Subject: Technical Letter: Assessment of *Centro de Gestión de Residuos Sólidos en el Bordo Poniente*

Facility Location

Figure 1. Penetration to ICAO Annex 14 Conical Surface by Stacks at the Facility

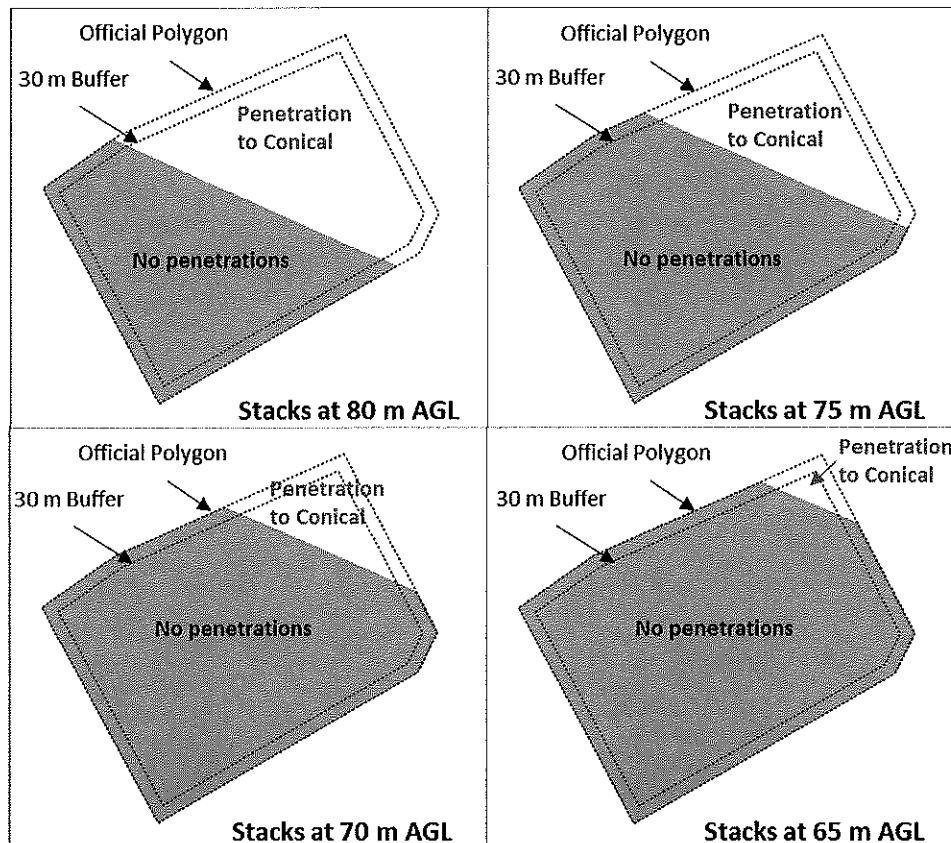
MITRE then evaluated the potential impact from the facility on ICAO Annex 14 OLS. MITRE determined that there is a penetration to the ICAO Annex 14 Conical surface within the polygon, even for a stack with a 65 m AGL height, worse for higher stacks (see Figure 1). It is also important to note that any changes in the ground elevation of the facility site could affect the results of MITRE’s overall OLS assessment.

The fourth conclusion is that the ICAO Annex 14 Conical surface is penetrated somewhere within the polygon even for stacks as short as 65 m AGL.

However, in this case, MITRE's assessment of the facility has raised important operational and safety concerns. Therefore, in MITRE's opinion, if a decision has to be made at this time regarding this facility, MITRE would advise against its development.
